COPPER CHASE AT STERLING RANCH

CONSTRUCTION PLANS

V2_CDs.pdf Markup Summary

EX BYNUM DRIVE AND BLUE FEATHER LOOP (STA 5+60.95)

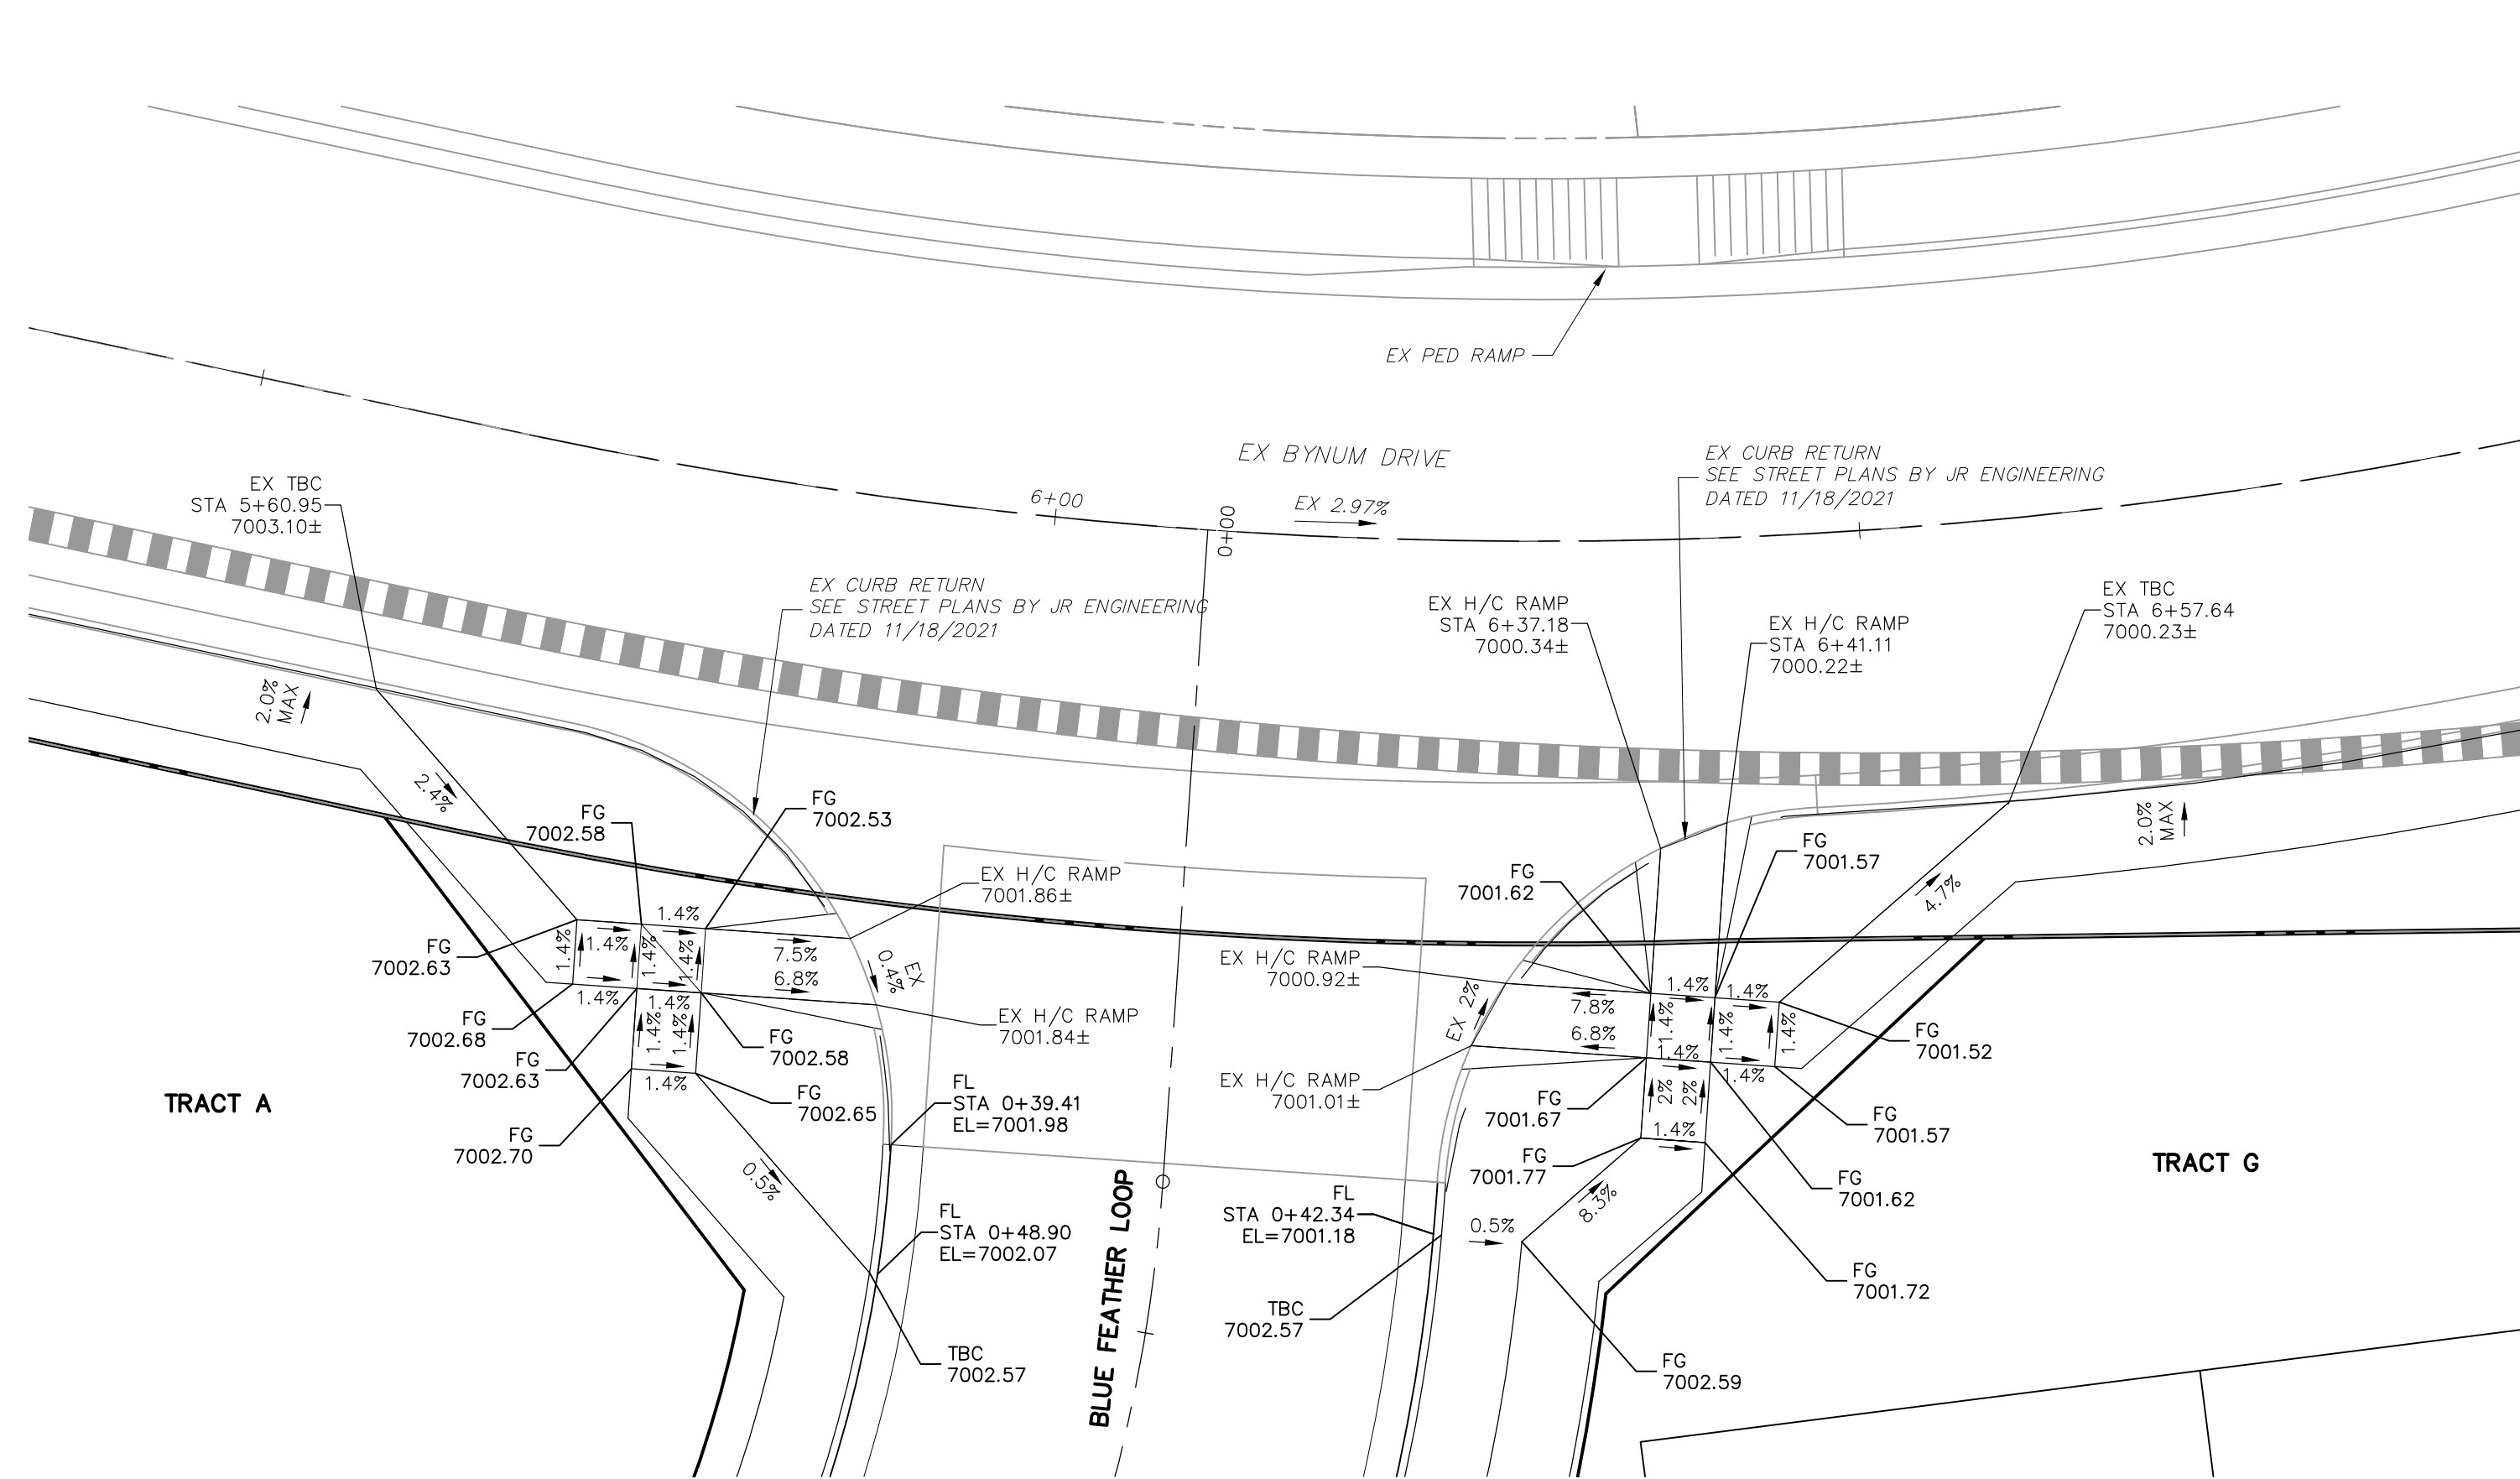
Provide elevation of HP

Provide elevation of LP

Provide elevation of LP
